PURCHASING SECTION
13450 – 104 Avenue, Surrey BC V3T 1V8
Tel: 604-590-7274
E-mail: purchasing@surrey.ca
ADDENDUM #3

REQUEST FOR QUOTATIONS (RFQ) NO.: 1220-040-2016-096
TITLE: MECHANICAL ROOM ADDITION AND GALLERY
HVAC UPGRADE – SURREY ARTS CENTRE
ADDENDUM ISSUE DATE: October 6, 2016
REVISED CLOSING DATE: prefer to receive Quotations on or before:
Wednesday, October 12, 2016

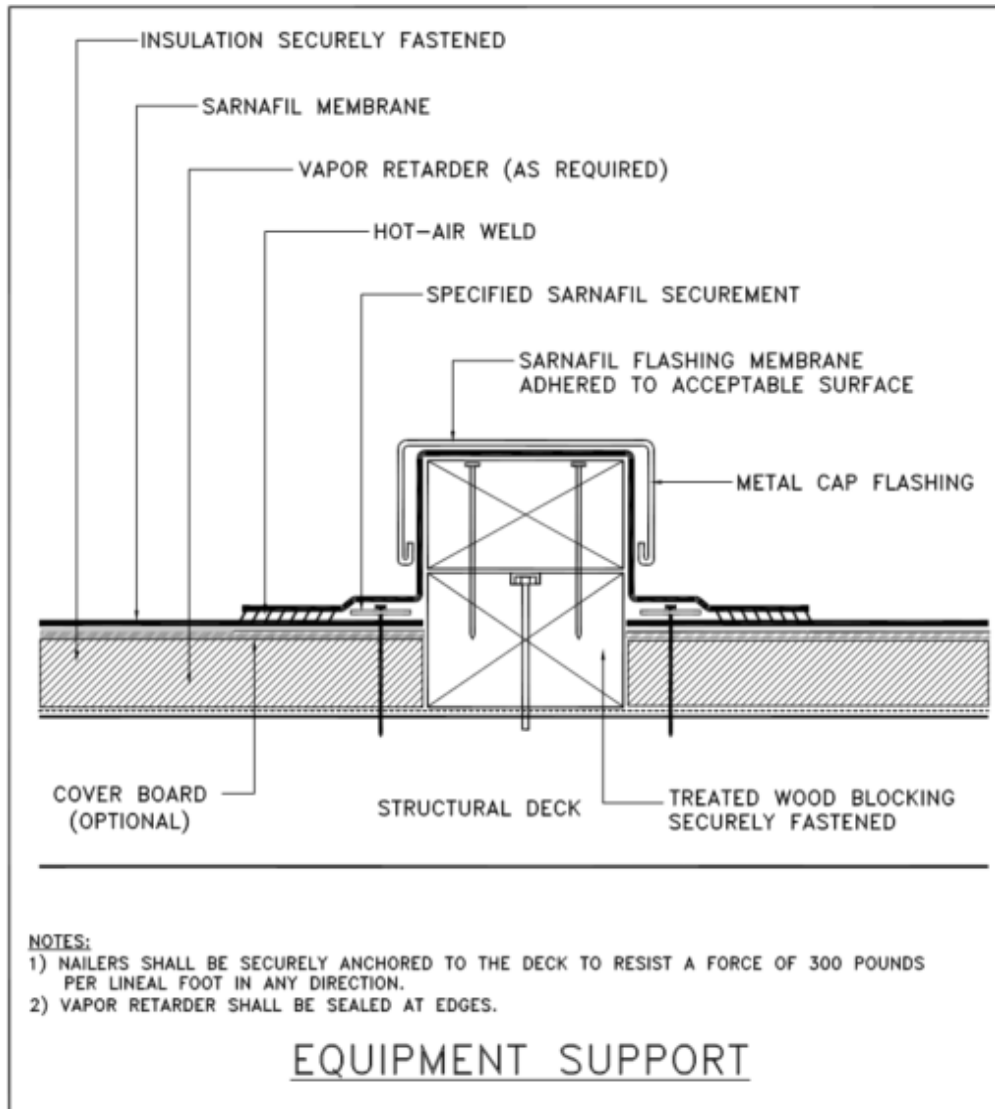
Q10: Drawing M501 – What is the roof curb/mounting detail for new unit CH-1?

A10: The new chiller will be installed as per the manufacturer's installation guidelines, which include group of anti-vibration isolators that will be installed under the unit base. The anti-vibration isolators shall be placed on the new roof equipment support sleepers, which will be provided by the contractor (see below for a typical detail).
